# UNITED STATES PATENT AND TRADEMARK OFFICE

10/728,833

<b>Office Action Summary</b>	<b>Application No.</b>	<b>Applicant(s)</b>	
	10/728,833	BRAEUER ET AL.	
	<b>Examiner</b>	<b>Art Unit</b>	
	Paul D. Kim	3729

### DETAILED ACTION

US 6,404,312 B1

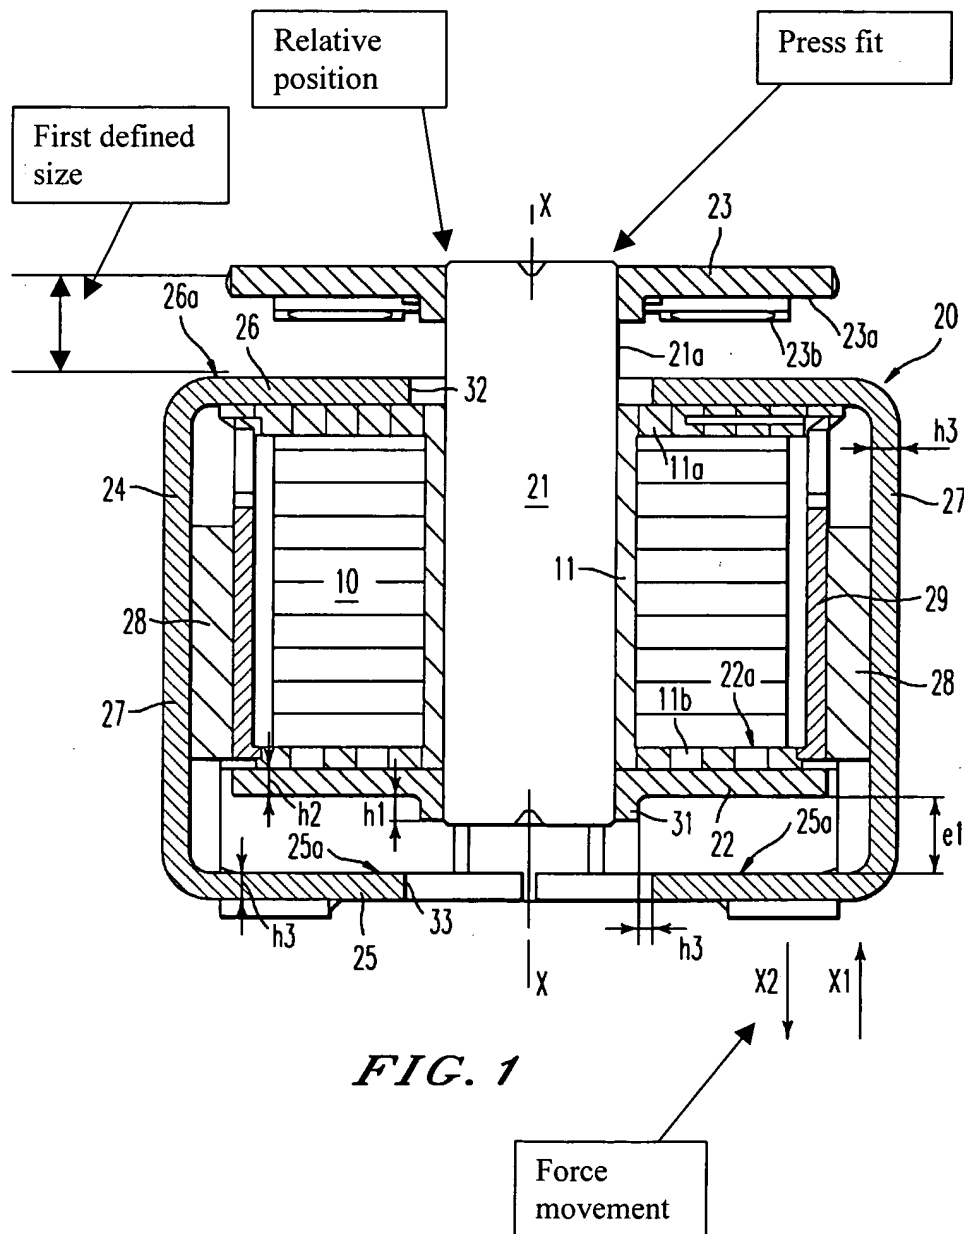
Comtois et al. teach a process of adjusting a spacing within a magnetic circuit comprising steps of: adjusting a relative position between an armature plate (23) and an armature bolt (21) by a pressing operation, to a first defined size, which is defined between the plate and the circuit, after the armature plate and the armature bolt are assembled to form the magnet armature as shown in Fig. 1, wherein the pressing force is applied to the preassembled magnet armature assembly until the first defined size is reached such as contact the plate to a surface of the circuit (26a) (see also col. 2, line 5 to col. 3, line 11). The armature plate (23) is fixed to the armature bolt (21) prior to adjust the relative position and the relative position is established by fixing the armature plate (23) to the armature bolt (21). Therefore, a press fit of the armature plate to the armature bolt is varied in terms of the relative position of the armature plate to the armature bolt as shown in Fig. 1.
